CERTIFICATE OF APPROPRIATENESS

**RE: Application Number 20-6985; 427 Henry; Cass-Henry Historic District
Project Scope: Rehabilitate Apartment Building**

RE: 427 Henry—The Henry

HENRY STREET REDEVELOPMENT

Sheet
5A101

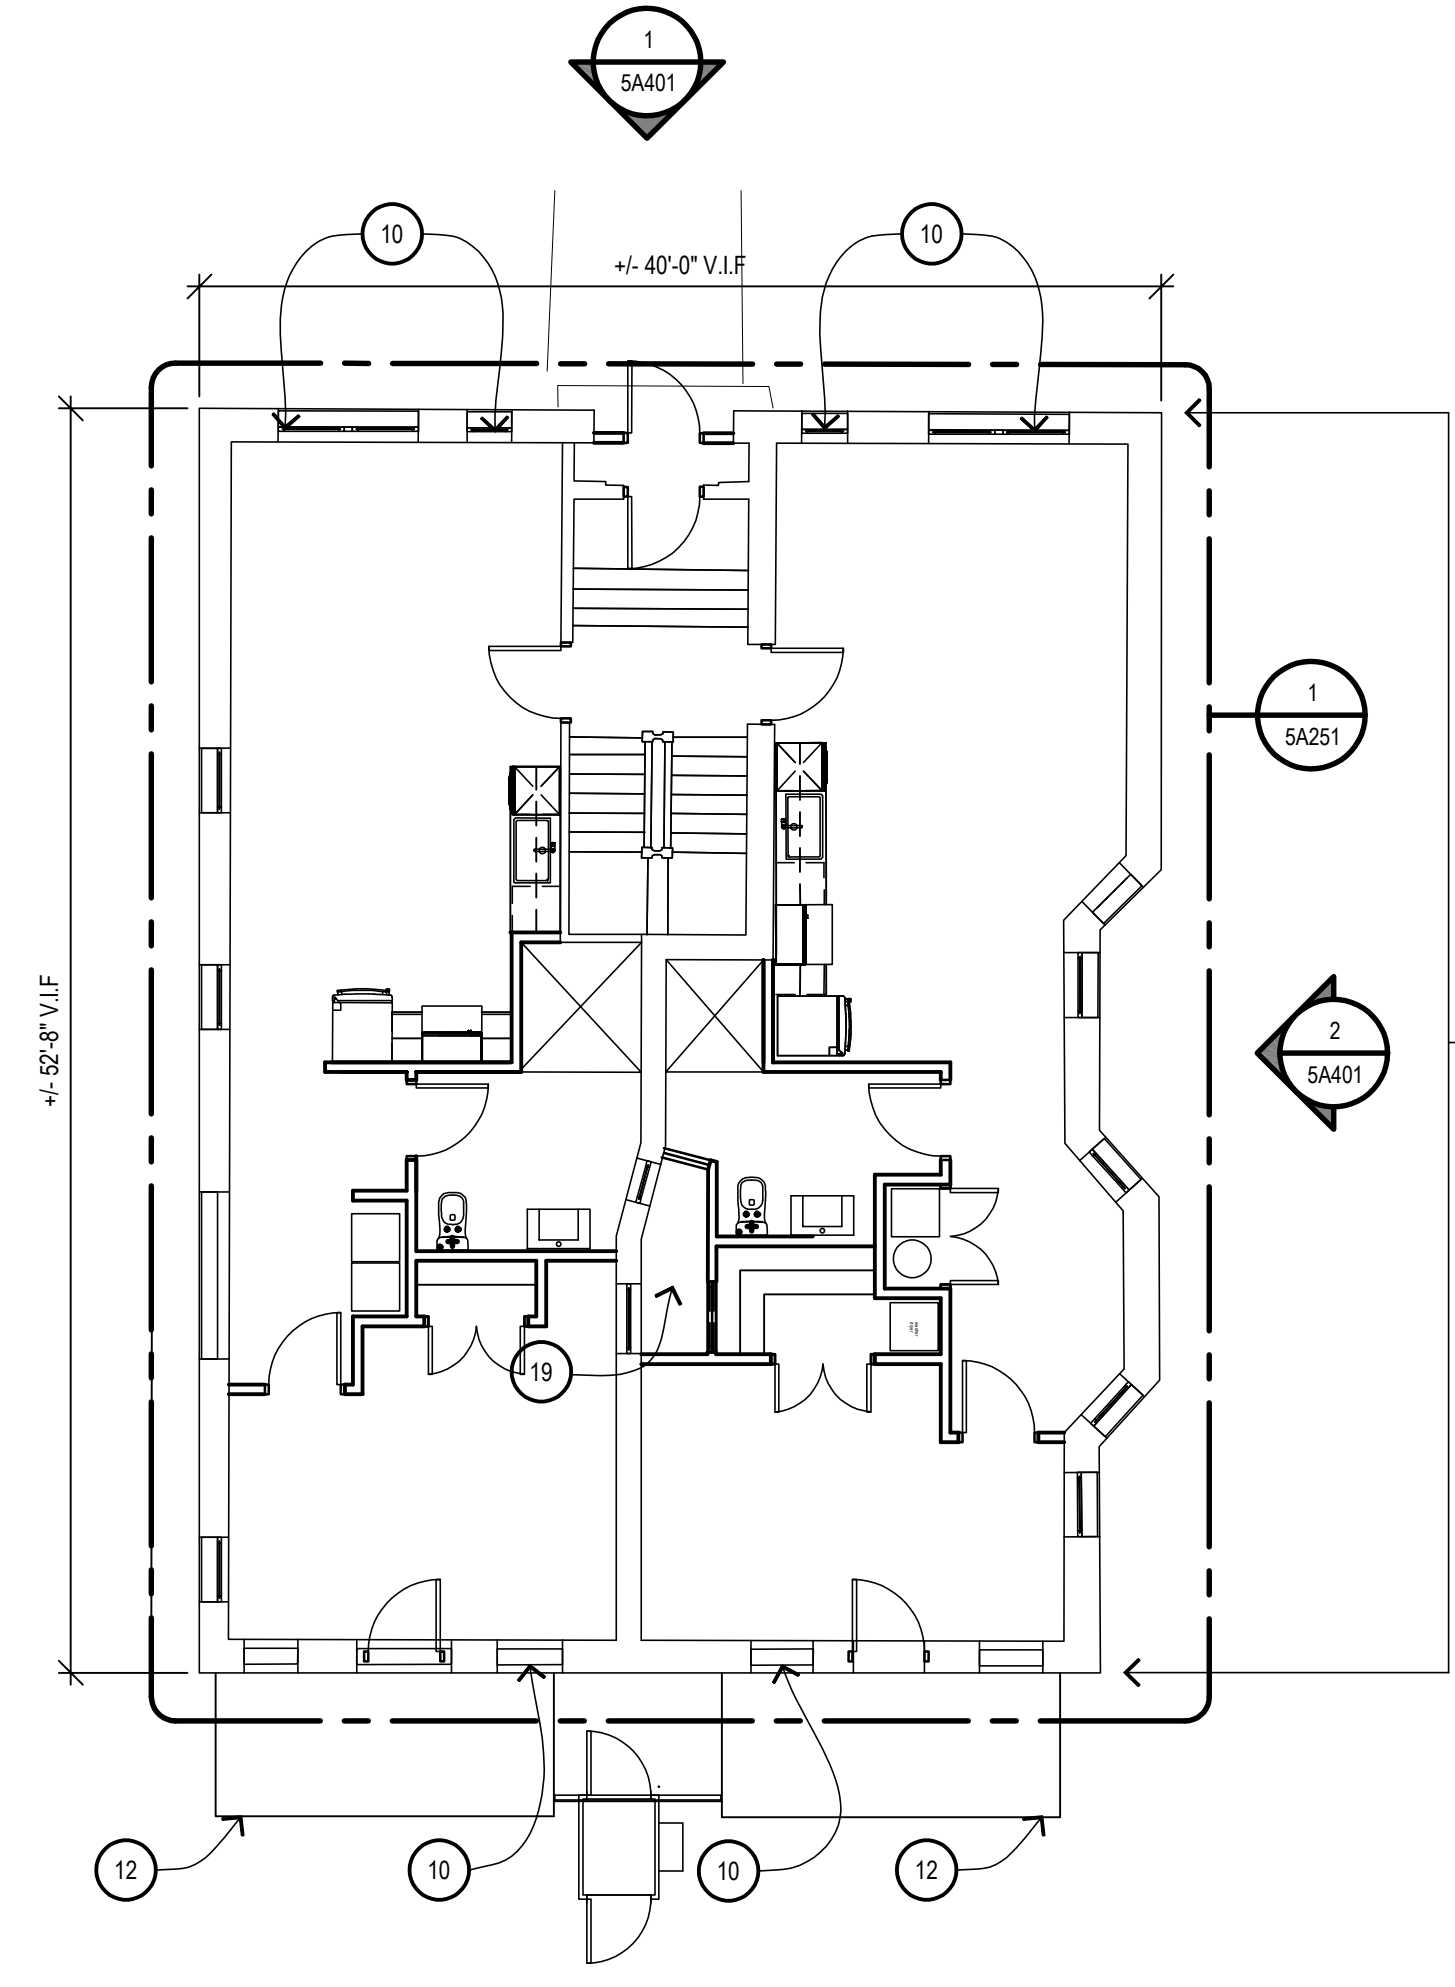
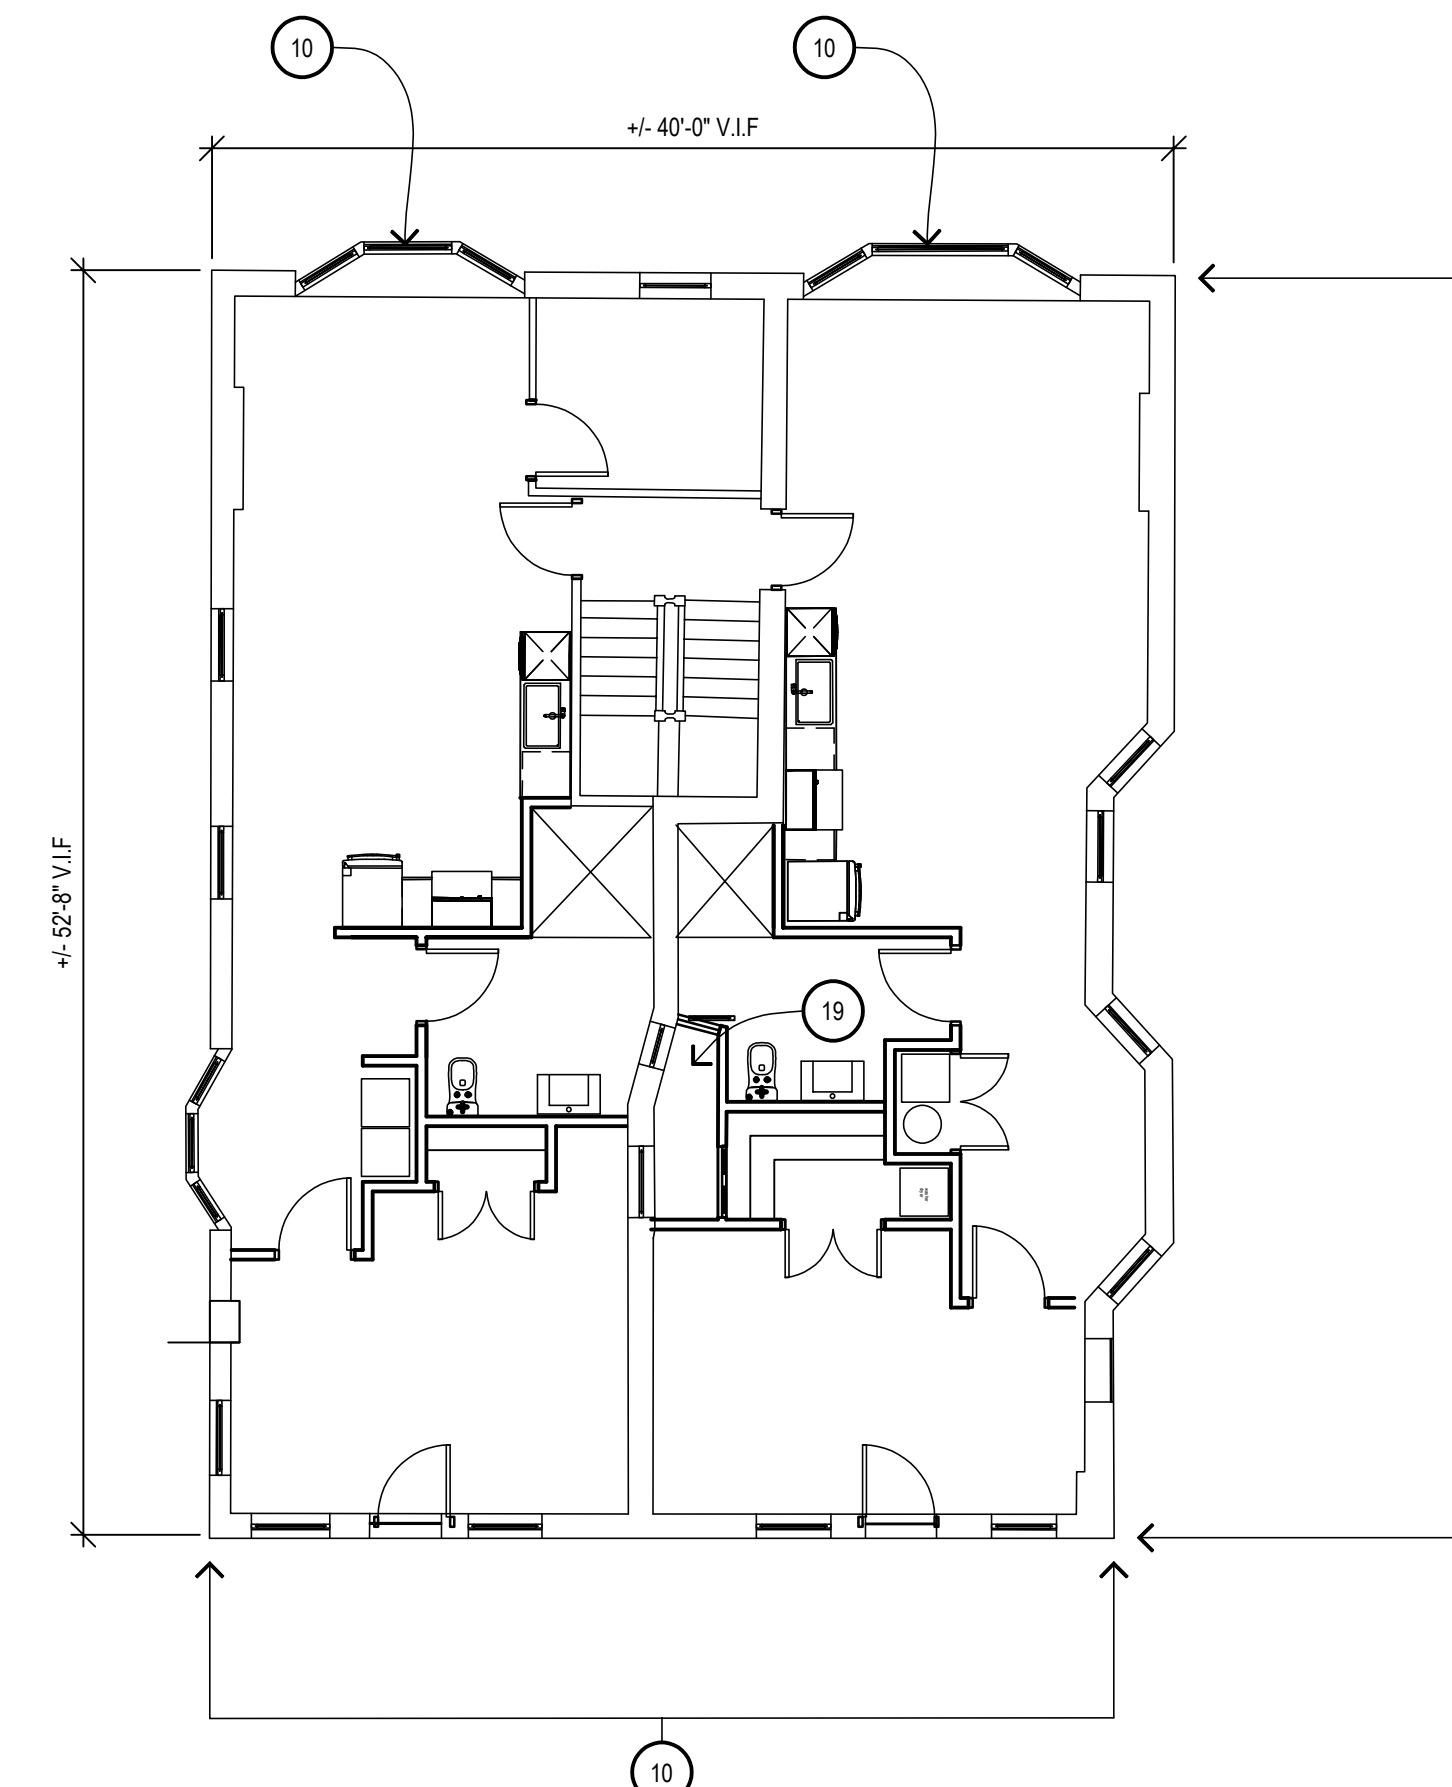
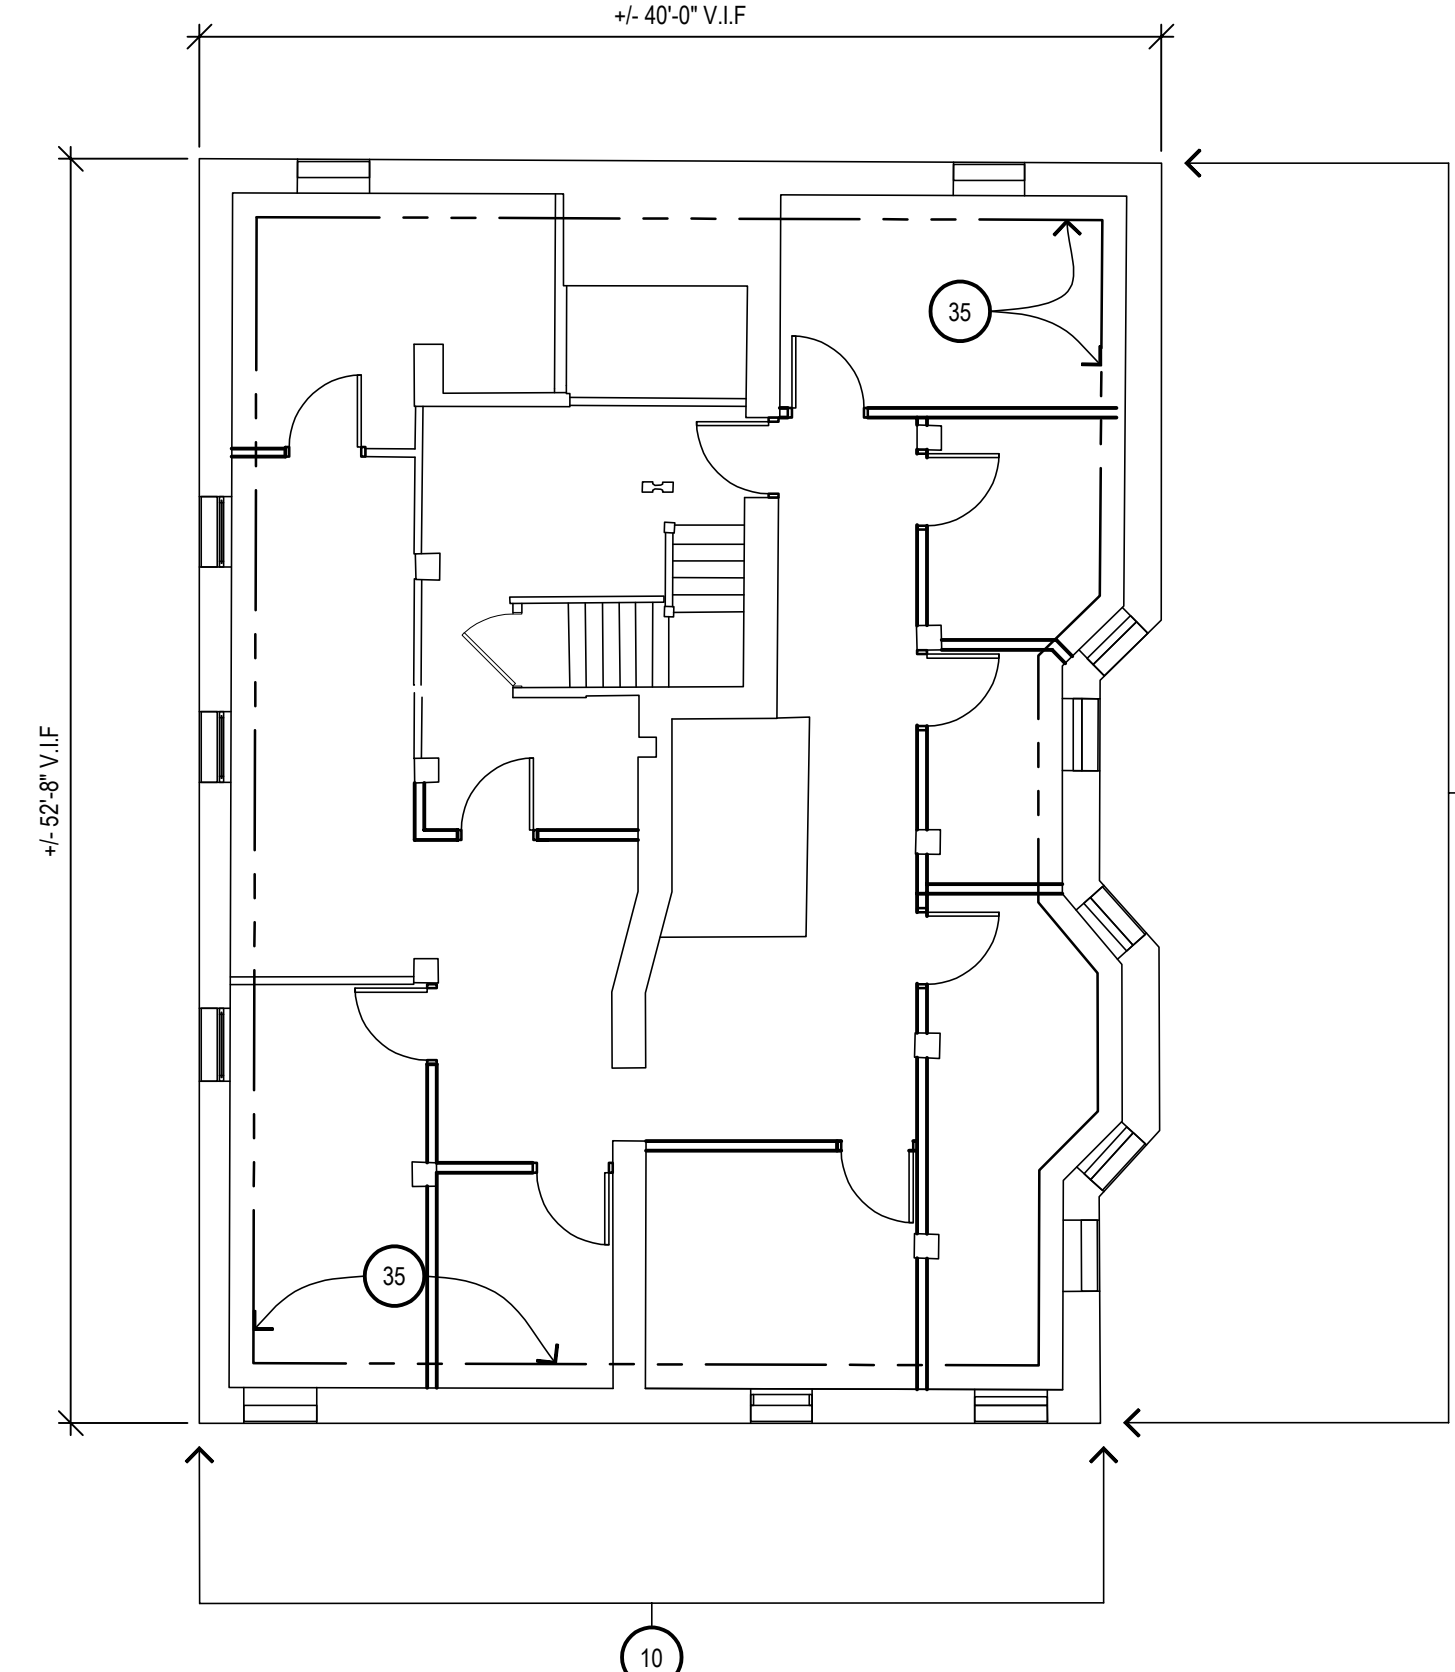
- *Current poor condition membrane roof to be removed and replaced with a new EPDM roof*
- *Small condensers will be added to the center and western side of the roof with painted metal panel mechanical screens to obscure the condensers*
- *Existing rooftop penthouses will be rehabilitated and retained*

And, as per the submitted documents, specifically drawings 5A101 (floor/roof plans), 5A401, 5A401.1 (elevations), and 5A421 (window details).
